Work Order ID 162104

Item Name: Bracket

DRAWING NO. D3016	TITLE SEAT FRAME ASSEMBLY	REV. A	DART AEROSPACE LTD ENGINEERING ORDER	D.E.O. NO. D3016-A-1	SHEET NO. SHEET 1 OF 1	SCALE NTS
DRAWN <i>1</i>	CHECKED <i>UP</i>	MFG. APPR. <i>BE</i>	APPROVED <i>MP</i>	DE APPR. <i>MP</i>		
DATE 10.01.29	DATE 10.01.29	DATE 10.01.29	DATE 10.01.29	DATE 10.01.29

TO REVISE D3016-11 SADDLE'S HOLE SIZES

D3016-11 SADDLE

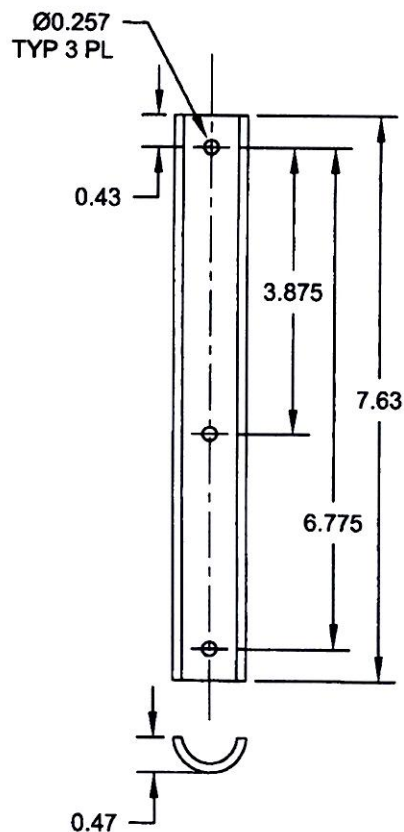
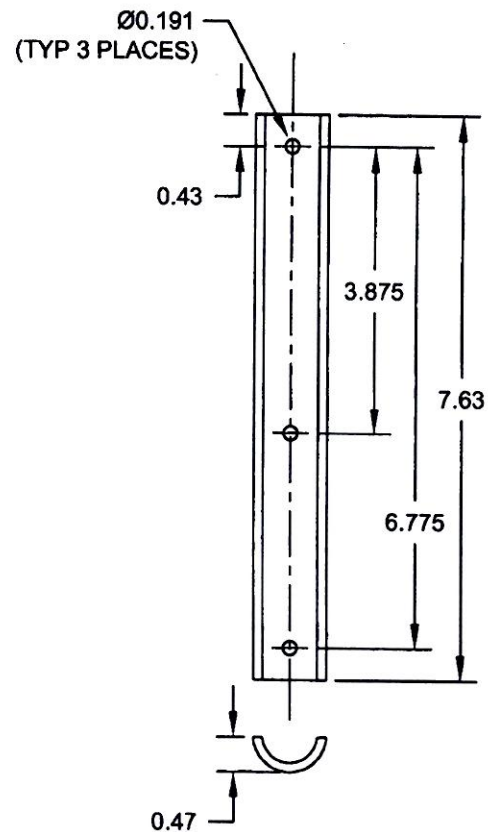
DETAIL D3016-11 SADDLE (SHEET 3): Ø0.257 TYP 3 PL WAS Ø0.191 (TYP 3 PLACES) AS SHOWN:

IS:
